From: Cargill, Dan (ECY) [DACA461@ECY.WA.GOV]
Sent: Friday, March 23, 2007 11:50 AM
To: Jennie Goldberg; Tiffany, Bruce; Renaud, Rick; Flint.Kris@epamail.epa.gov; beth.schmoyer@seattle.gov
Subject: FW: NBF Soil Investigation Work Plan
Attachments: Soil Inves SAP.pdf

From: Edens, Mark (ECY)
Sent: Friday, March 23, 2007 11:43 AM
To: Bach, Carl M
Cc: Cargill, Dan (ECY)
Subject: RE: NBF Soil Investigation Work Plan

**Sampling and Analysis Plan
Soil Investigation
North Boeing Field
Seattle, Washington**

Figure
2

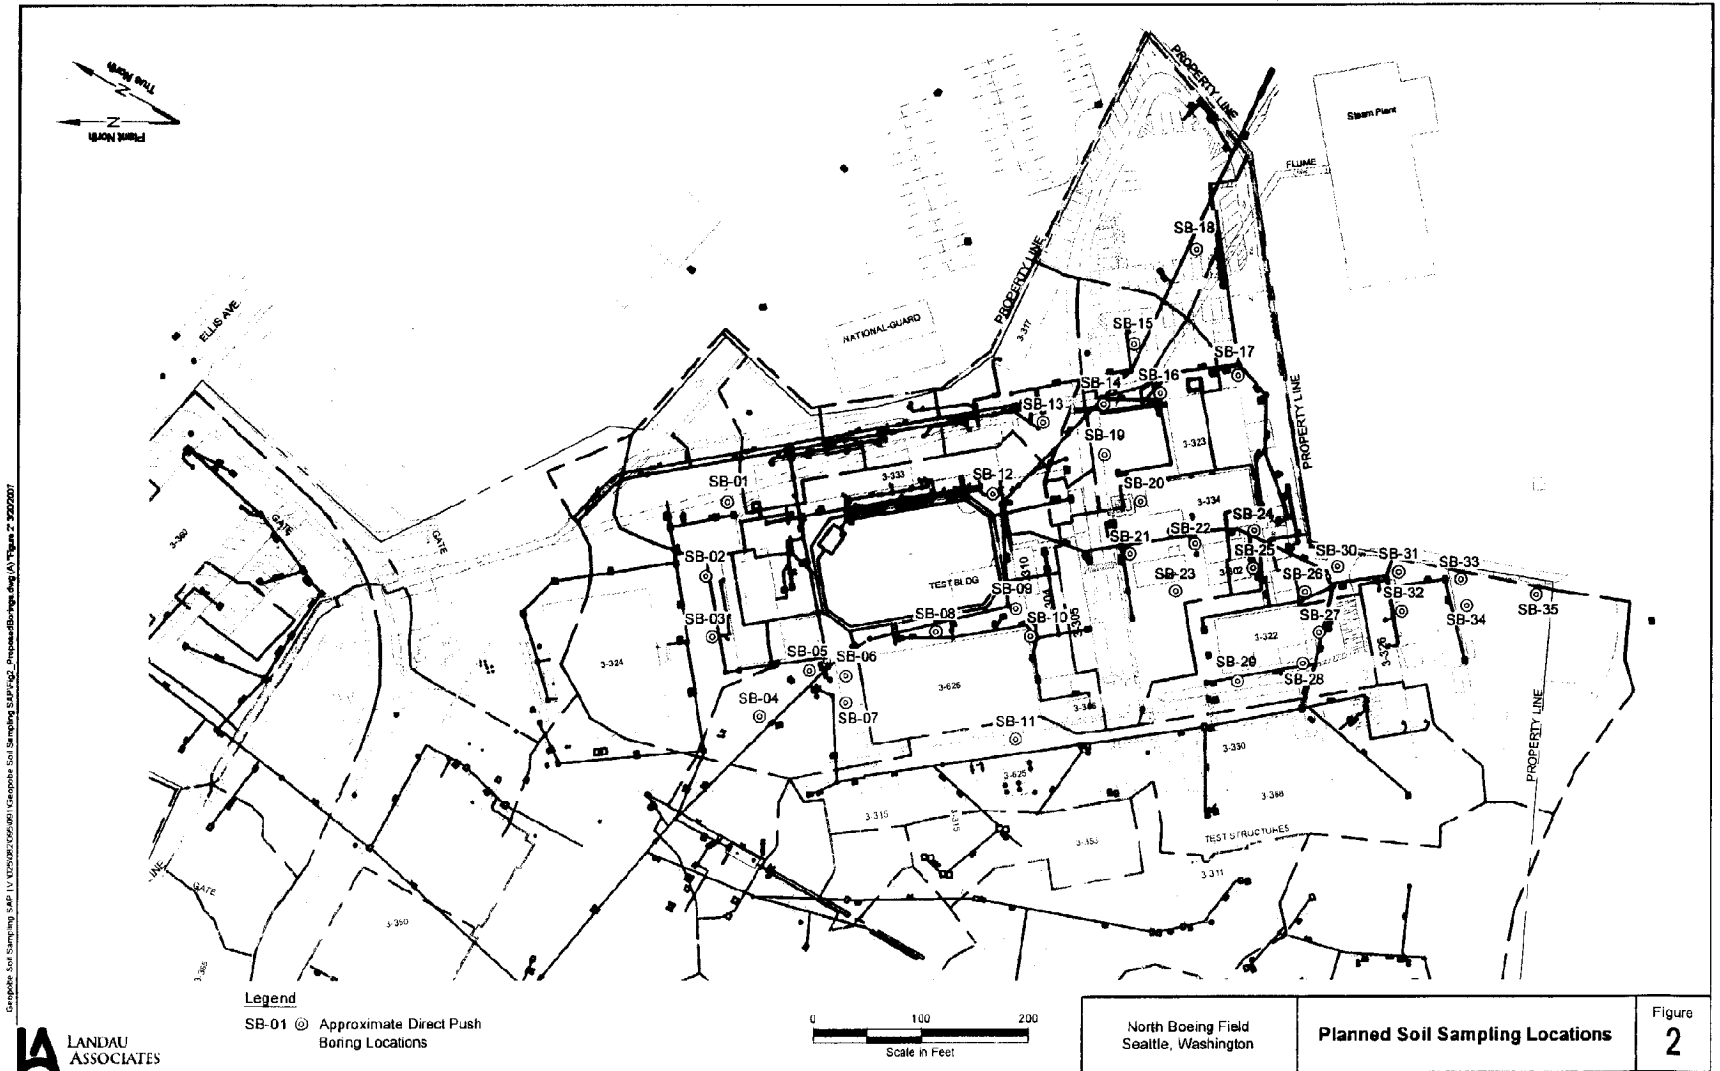
2. Additional soil sampling is recommended near the southern limits of the drainage basin that contains building 3-353. As part of a cleanup near this building in 1990, there was sampling and testing of soil for TPH in the vicinity of an electrical transformer and an underground vault. Soils were not tested for PCBs. Sampling and testing in this area might help delineate the southern extent of PCB soil contamination in this area of the site.

3. Recent sediment trap data shows that there are continuing high levels of PCBs in manholes 363 and 422. If recent pipe inspections indicate there might be soil infiltration immediately upstream from these manholes, additional soil sampling and testing is needed at these locations.

4. SB-02 should be either be moved slightly to the north or an additional sampling location added to provide data from the former location of MW-1 as shown in AGI Technologies' 1998 report *Remedial Action Report, Proposed West Wing 3-333 Building Fuel Test Laboratory*. Residual PCB concentrations after cleanup at this location in 1998 were as high as 380 mg/kg at the bottom of the excavation.
